UNITED STATES PATENT AND TRADEMARK OFFICE

APPLICATION NO.	FILING DATE	FIRST NAMED INVENTOR	ATTORNEY DOCKET NO.	CONFIRMATION NO.
10/518,748	07/26/2005	Hermann Raabe	095309.55705US	1320
23911	7590	02/27/2006	EXAMINER	
CROWELL & MORING LLP INTELLECTUAL PROPERTY GROUP P.O. BOX 14300 WASHINGTON, DC 20044-4300			PILKINGTON, JAMES	
			ART UNIT	PAPER NUMBER
			3682

Office Action Summary	Application No.		Applicant(s)	
	10/518,748		RAABE ET AL.	
	Examiner		Art Unit	
	James Pilkington		3682

DETAILED ACTION

Figure 1. Ganser's torque-transmitting joint.

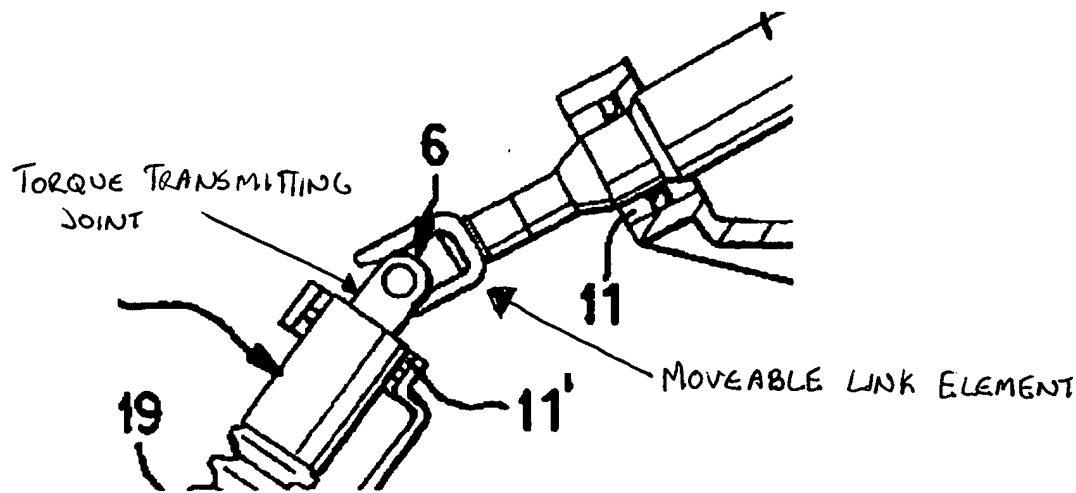
Re clm 1, Ganser discloses a steering spindle (8) which bears a steering wheel (2), a steering shaft (5) connected to the steering spindle (8), a torque-transmitting joint (See Fig 1 below) forming the connection between the steering spindle (8) and the steering shaft (5) and a second moveable link element (Fig 1 below).

Ganser does not disclose that said second moveable link element is an axially moveable for axial length compensation comprising at least one coupling member with two parallel axes of rotation, and a spigot cross element being coupled to the end of the steering spindle which lies opposite the steering wheel, one axis of the spigot cross element forming an axis of rotation for the coupling member, wherein the steering shaft has a flange which ends at a distance from the longitudinal axis of the steering shaft, the flange executing a pivot movement about the upper axis of rotation of the coupling member.

Figure 2. Bouchard's extensible joint for motor vehicles. The examiner has added character references to better explain the drawing.

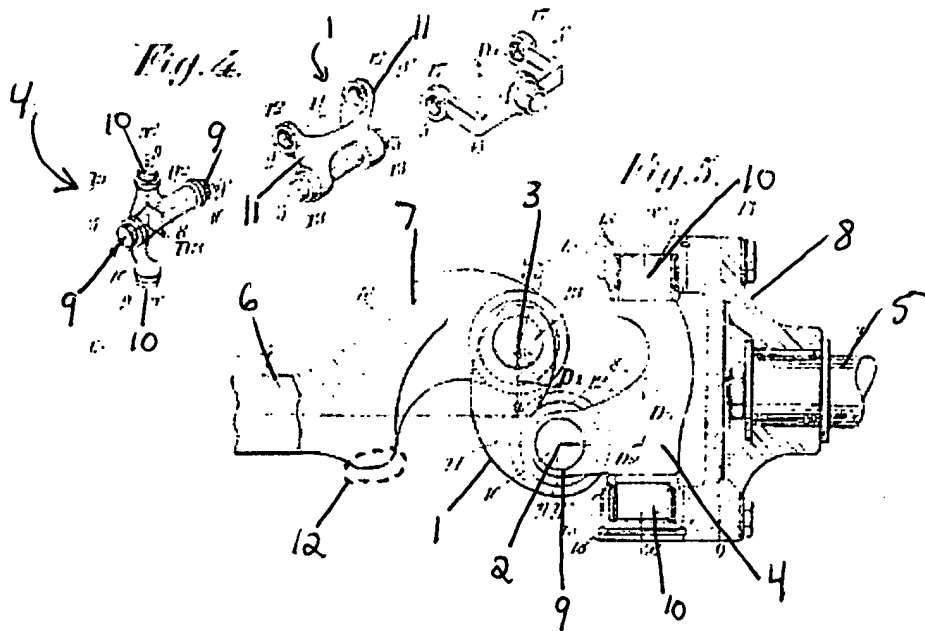
Bouchard teaches a moveable link element (Fig 4/5 or see Fig 2 below) for the purpose of allowing for relative variations of the orientations and respective axial

positions (col 1) comprising at least one coupling member (1) with two parallel axes of rotation (2,3), and a spigot cross element (4) being coupled to the end of the steering spindle (5) which lies opposite the steering wheel, one axis of the spigot cross element (4) forming an axis of rotation (2) for the coupling member (1), wherein the steering shaft (6) has a flange (7) which ends at a distance from the longitudinal axis of the steering shaft, the flange executing a pivot movement about the upper axis of rotation (3) of the coupling member (1).

It would have been obvious to one having ordinary skill in the art at the time of the invention to modify the teachings of Ganser and provide an axially moveable link element, as taught by Bouchard, for the purpose of allowing for relative variations of the orientations and respective axial positions.

Re clm. 2, Bouchard discloses the spigot cross element (4) being mounted in a forked joint (8). From the combined invention of Ganser and Bouchard discussed above said forked joint will be arranged at the end of the steering spindle which lies opposite the steering wheel.

Re clm. 3, Bouchard discloses two transverse spigots (9) of the spigot cross element (4) form a transverse bolt of the coupling member (1).

Re clm. 4, Bouchard discloses two longitudinal spigots (10) of the spigot cross element (4) form a pivot axis of the forked joint (8).

Re clm. 5, Bouchard discloses that the coupling member (1) comprises two side plates (11) through which two transverse bolts pass, the transverse bolts form the axes of rotation (2,3) of the coupling member (1).

Re clms. 6, 8, 10, 12 and 14, Bouchard discloses the flange being provided with an additional mass (12).
